TWIN CHIMNEYS

VILLAGE F

PLAT THREE

STORM & SANITARY SEWER MEASUREMENTS

STORM & SANITARY SEWER MEASUREMENTS

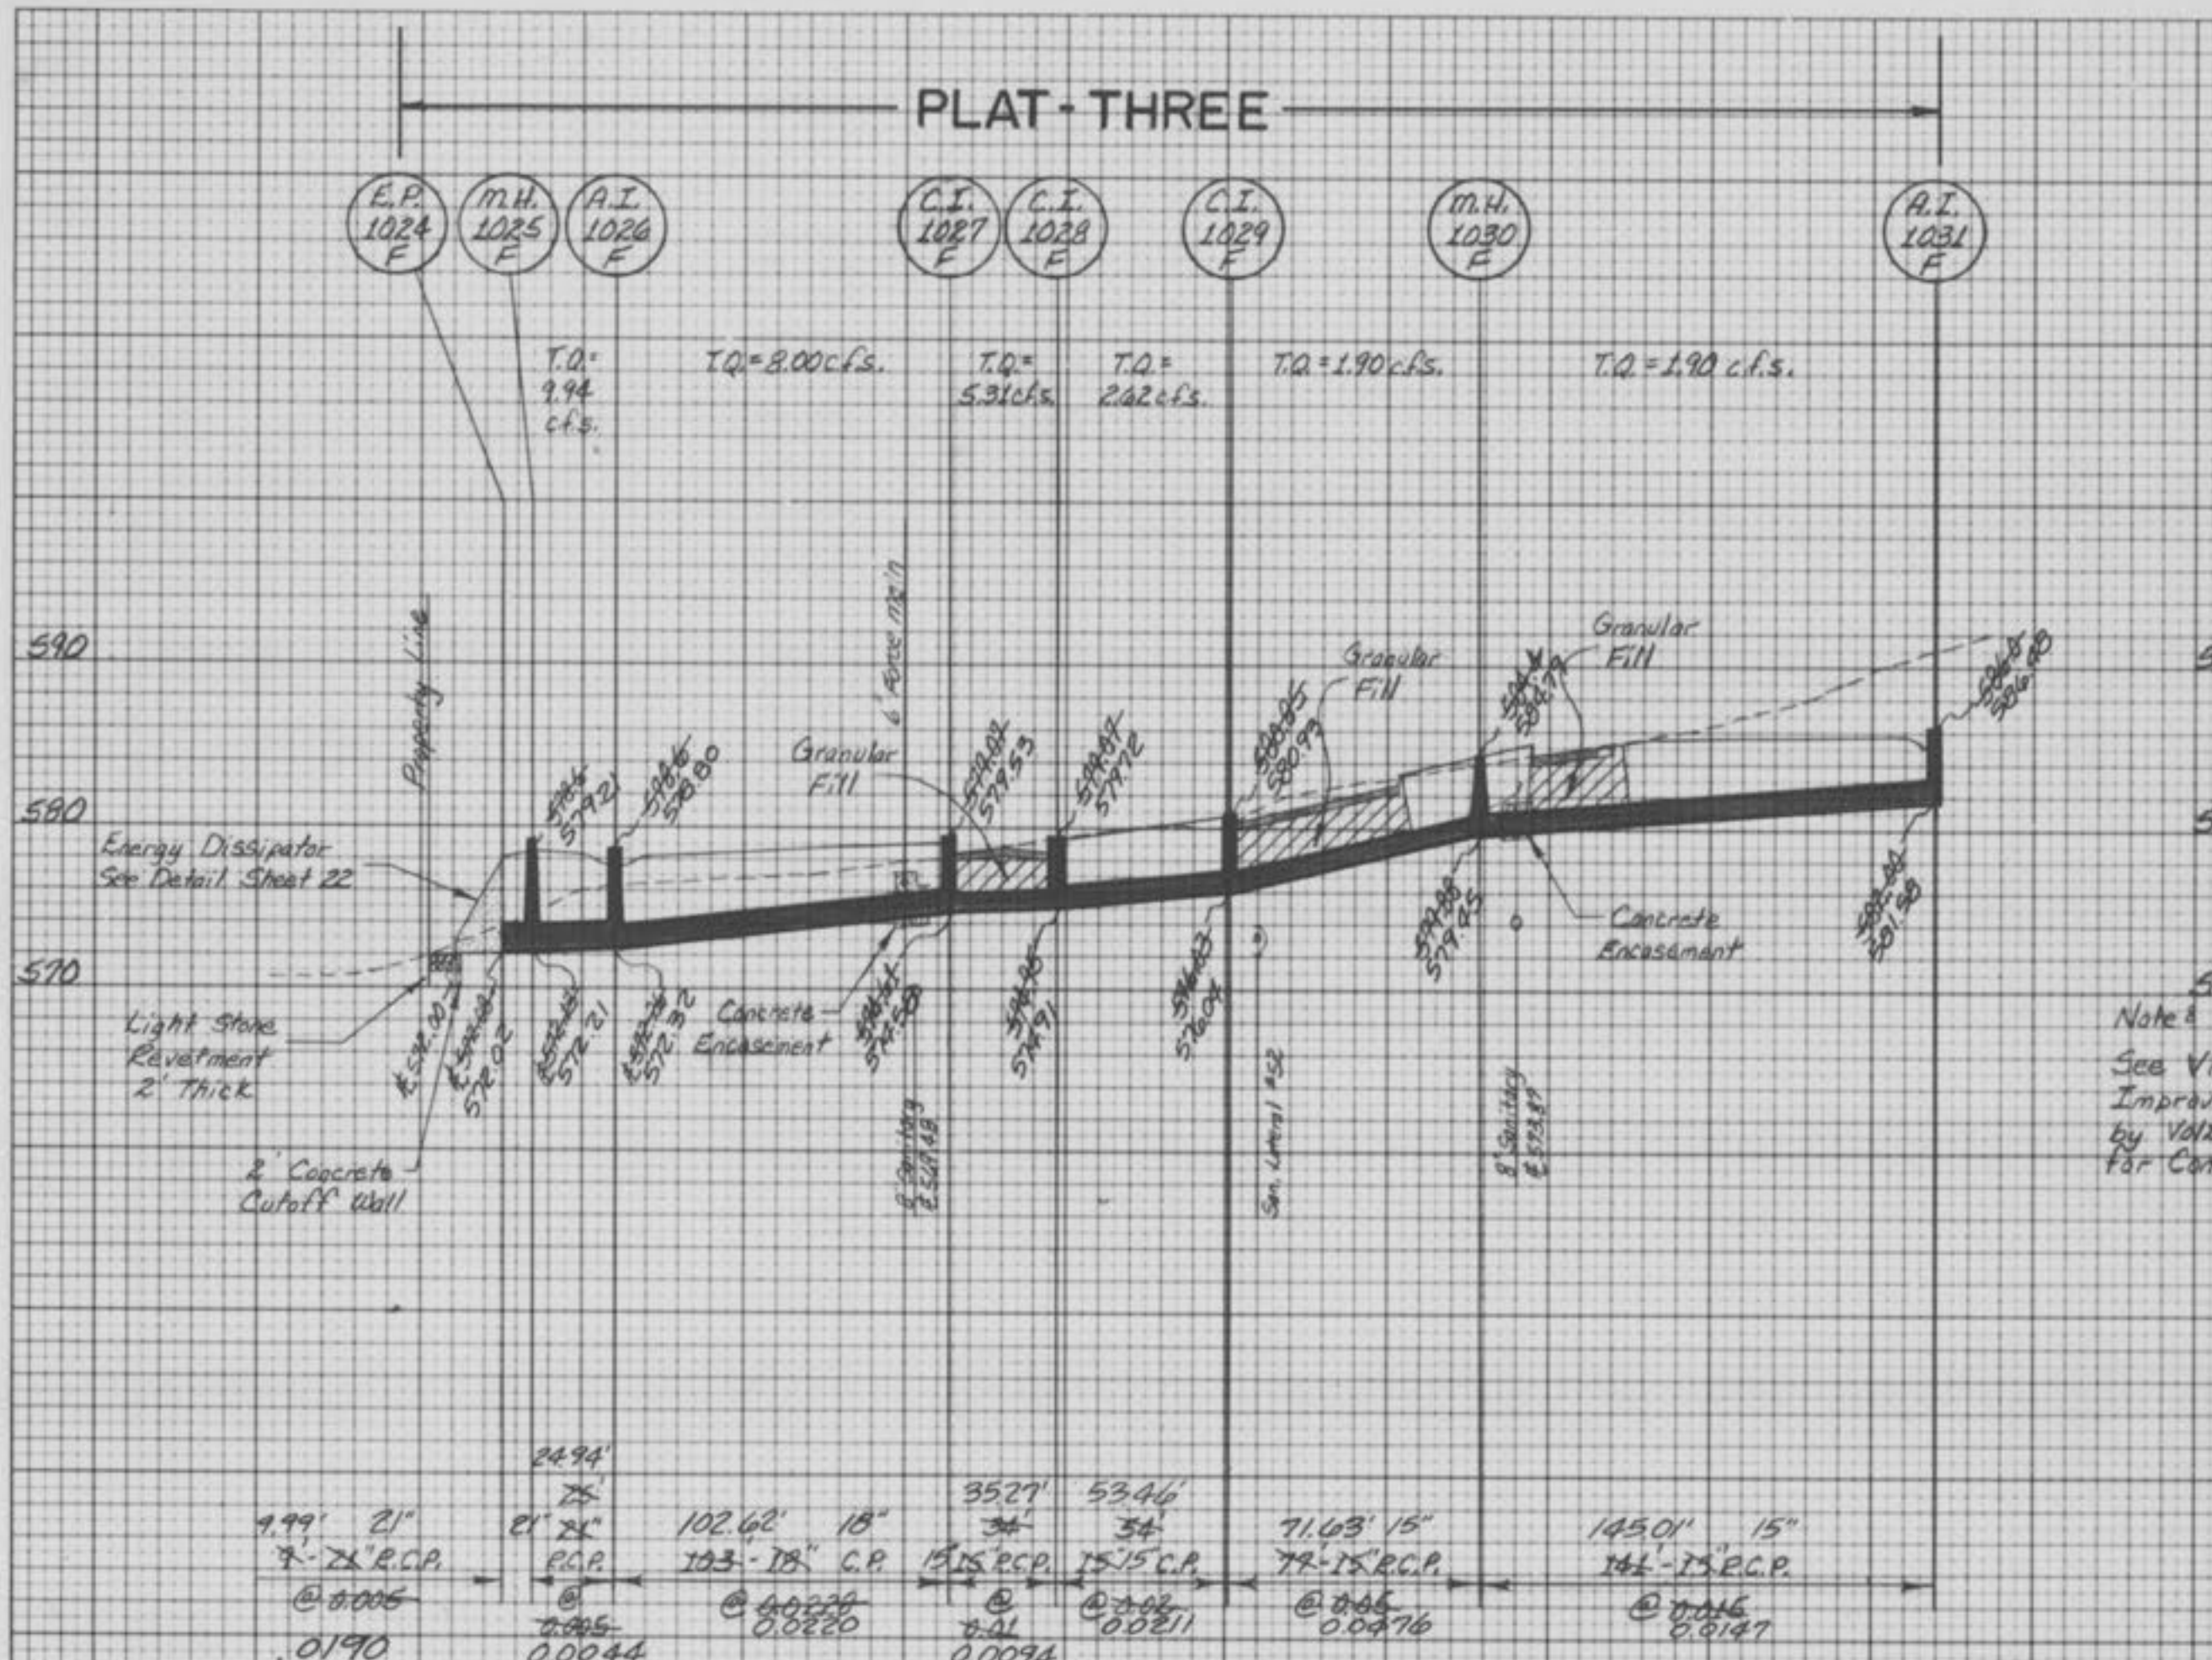
We have measured the existing sewer lengths, sizes, flowlines, depths of structures and the results of these measurements are shown on this plan by lining out the planned number and indicating the measured number adjacent to the planned number. All other numbers have not been measured or verified.

12/13

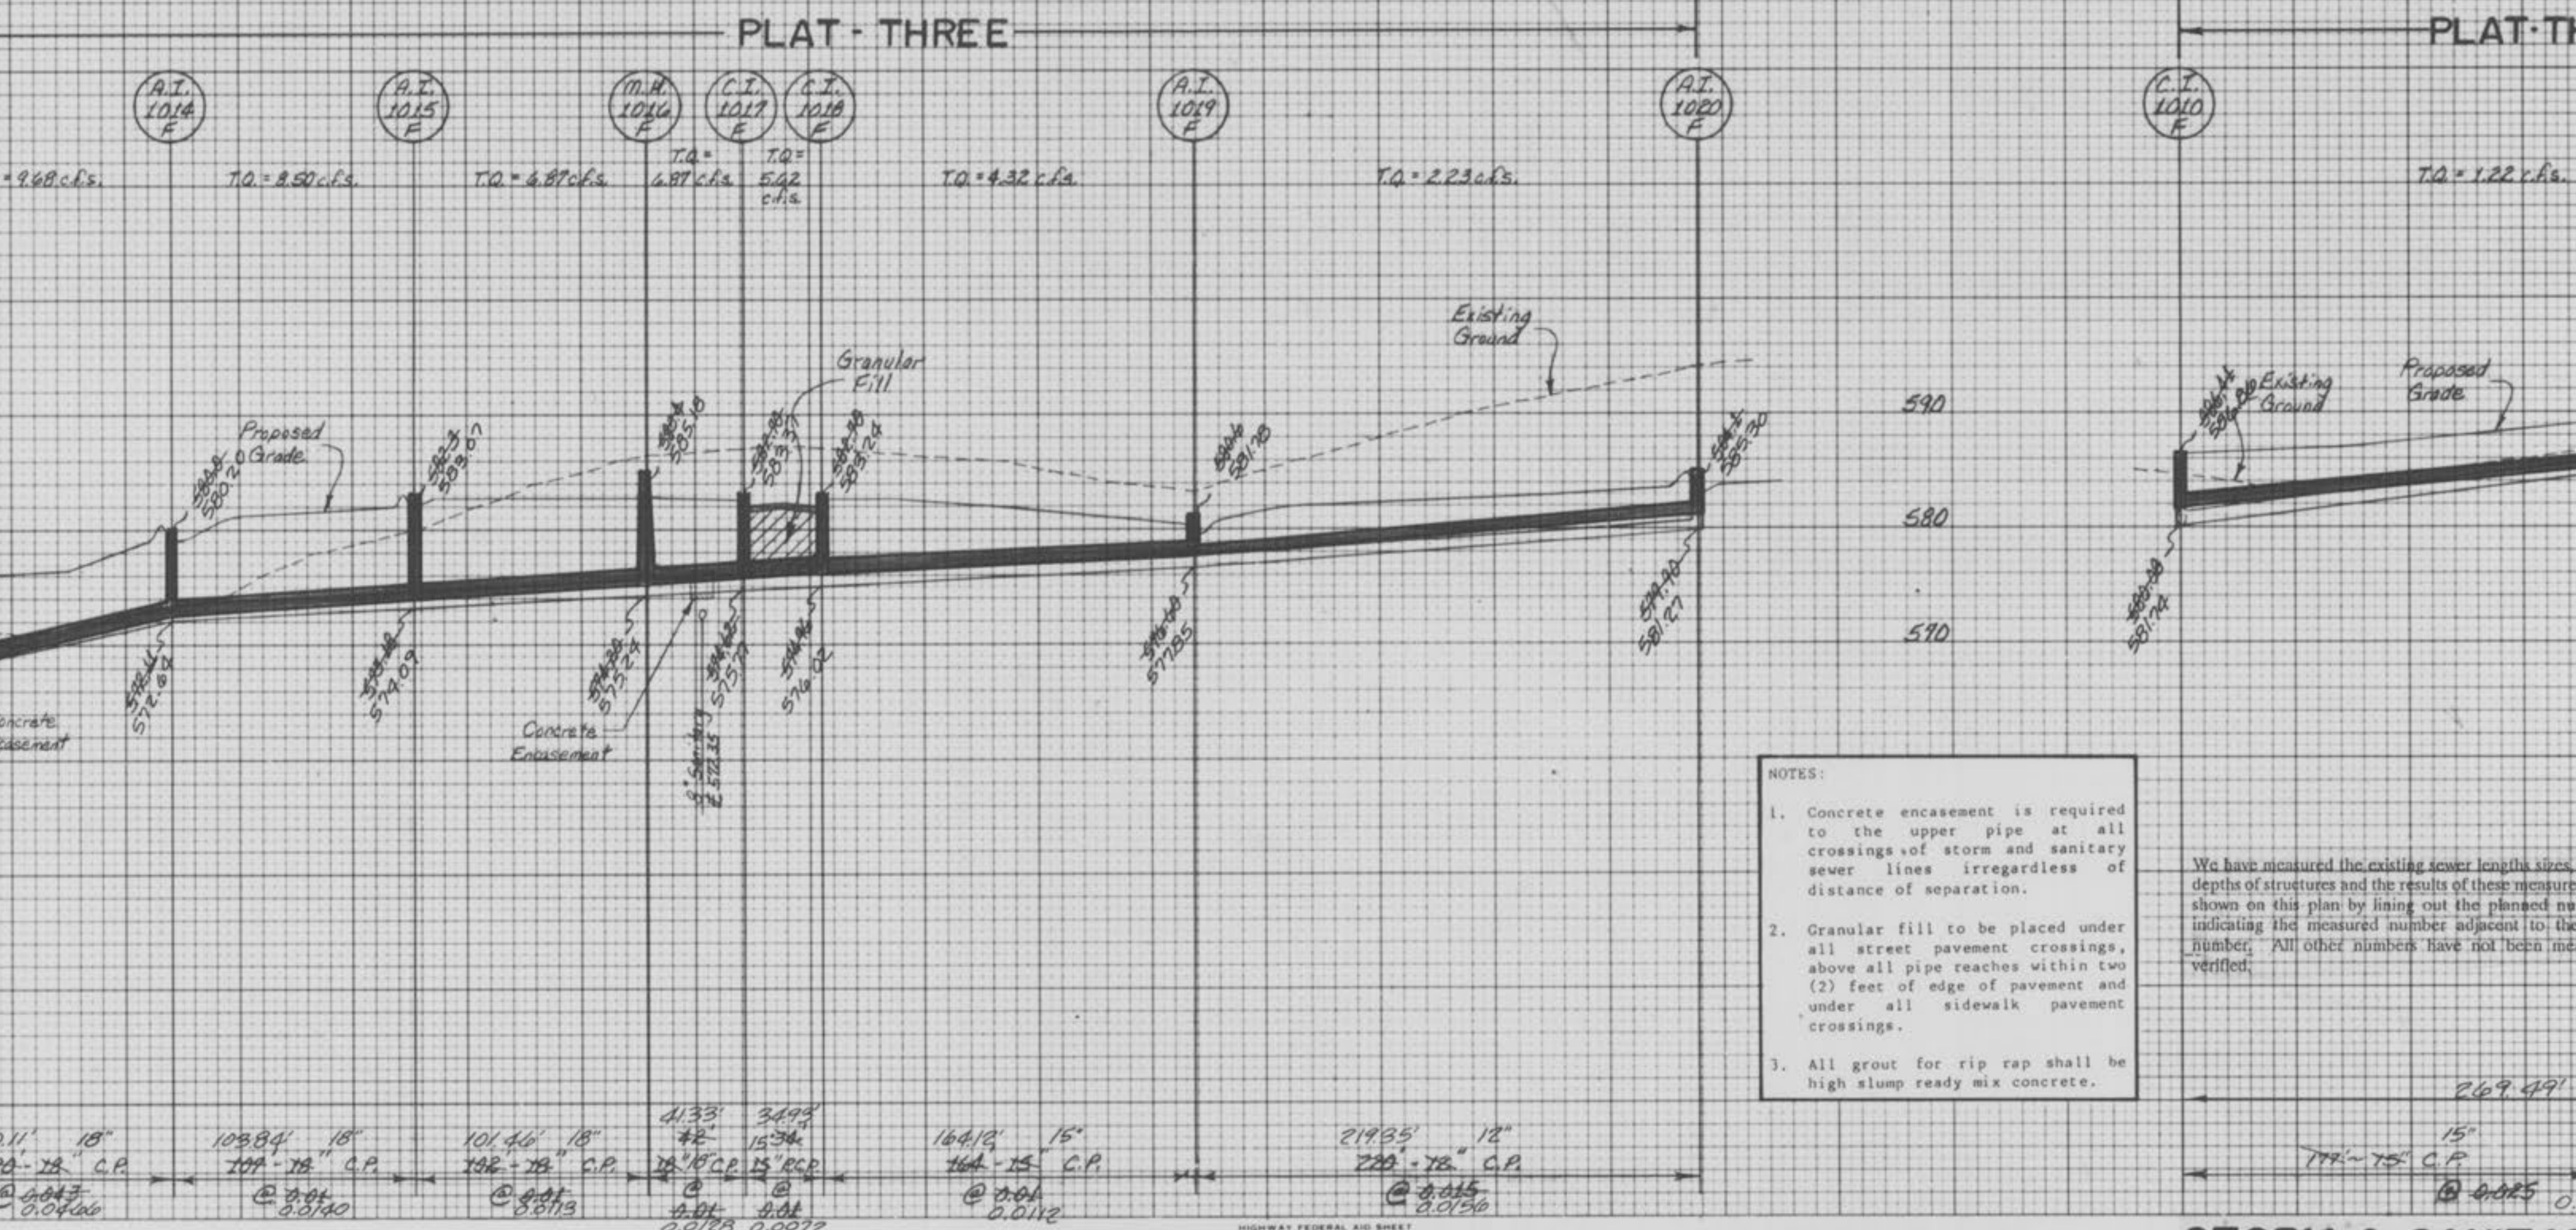
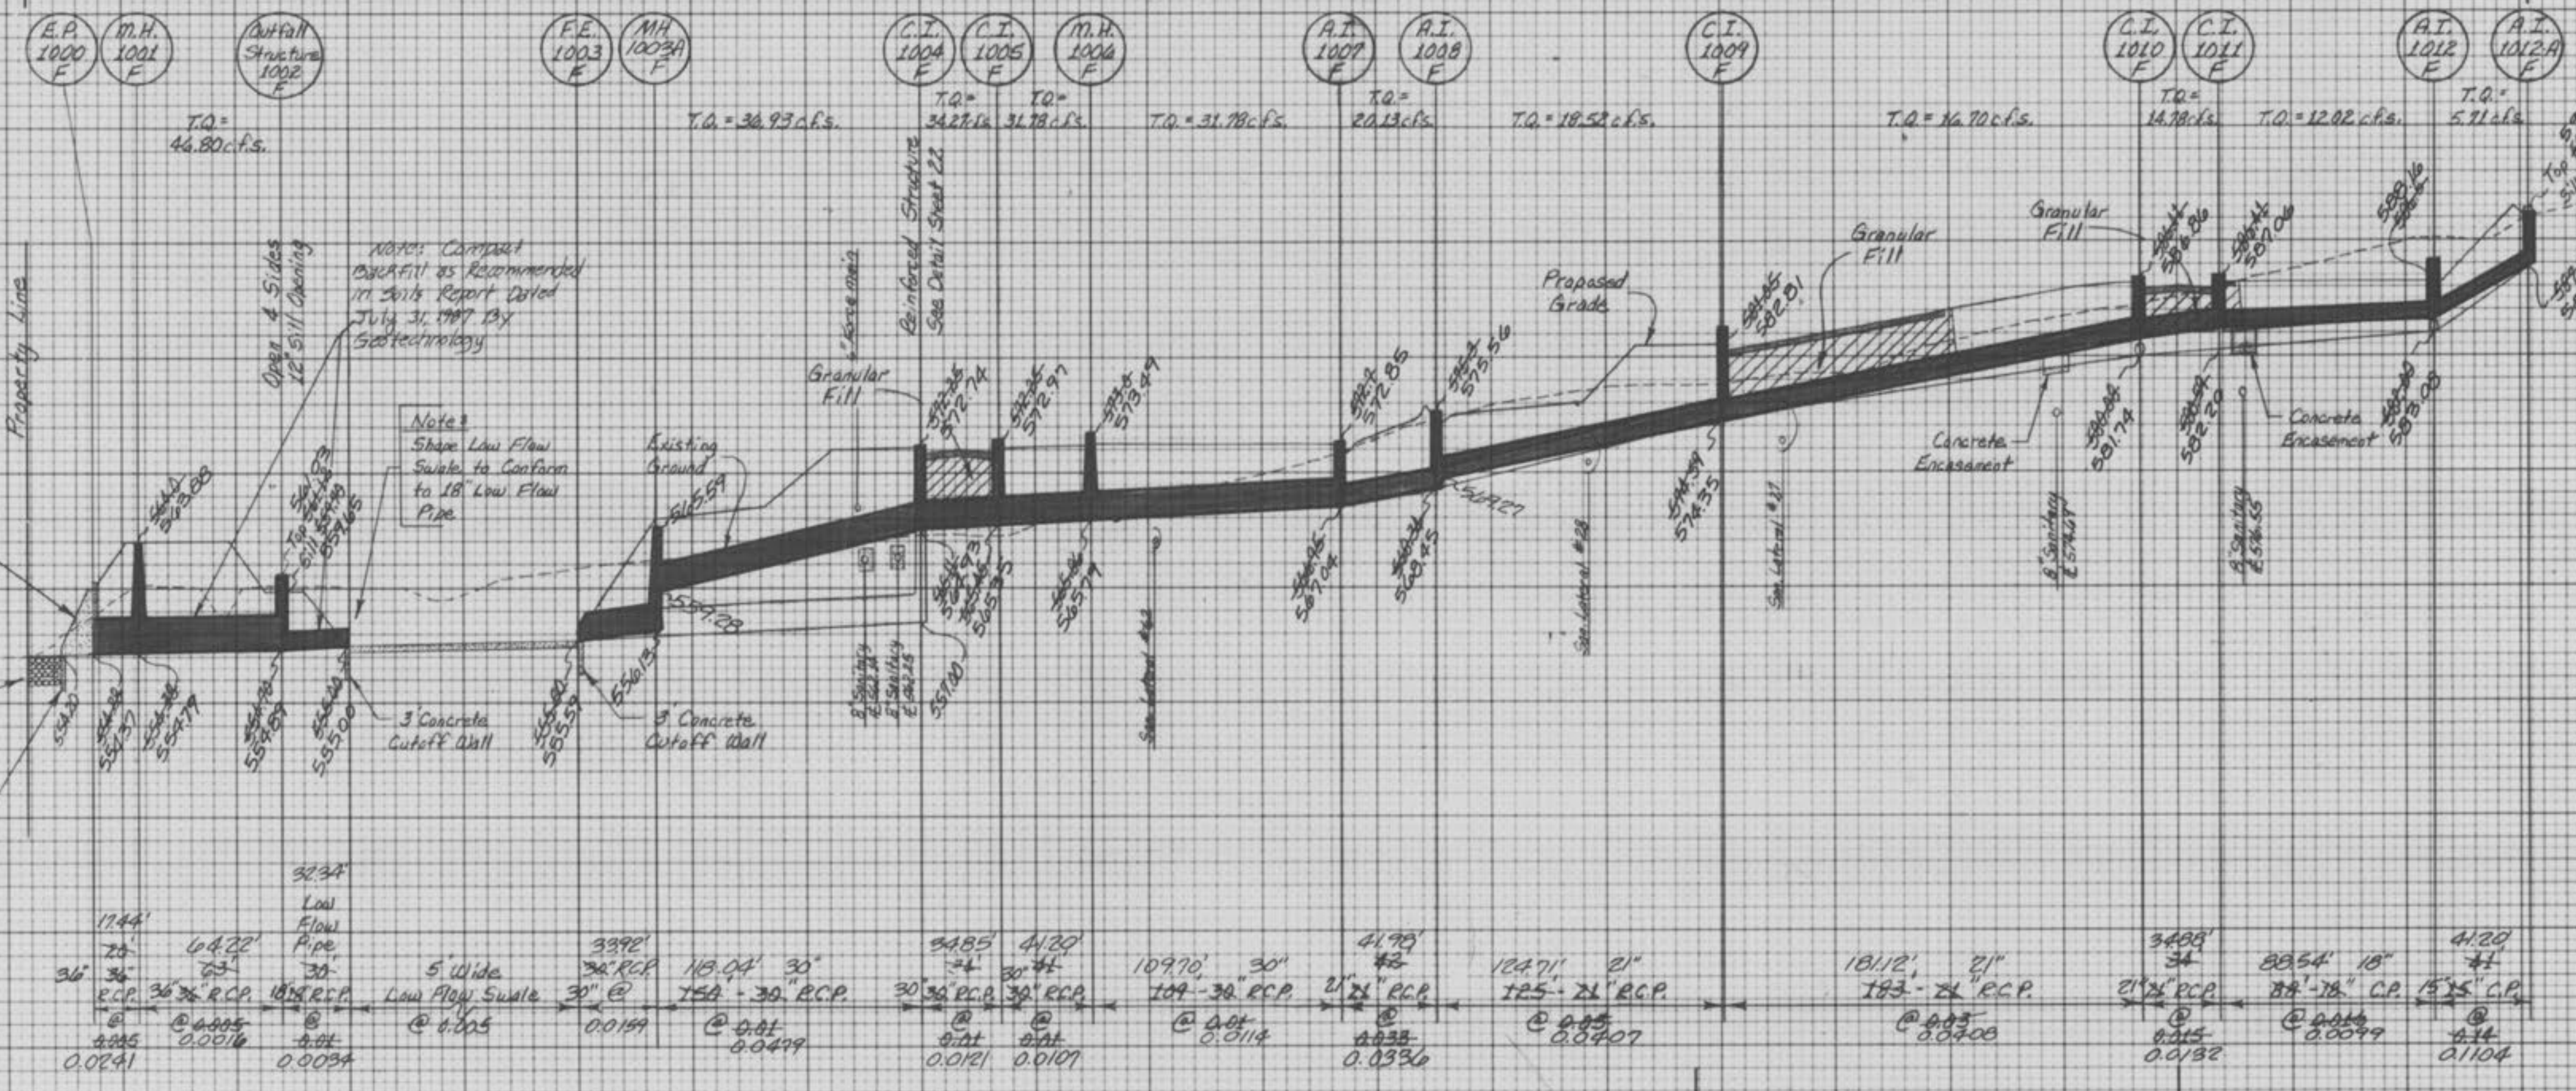
We have measured the existing sewer lengths, sizes, flowlines, depths of structures and the results of these measurements are shown on this plan by lining out the planned number and indicating the measured number adjacent to the planned number. All other numbers have not been measured or verified.
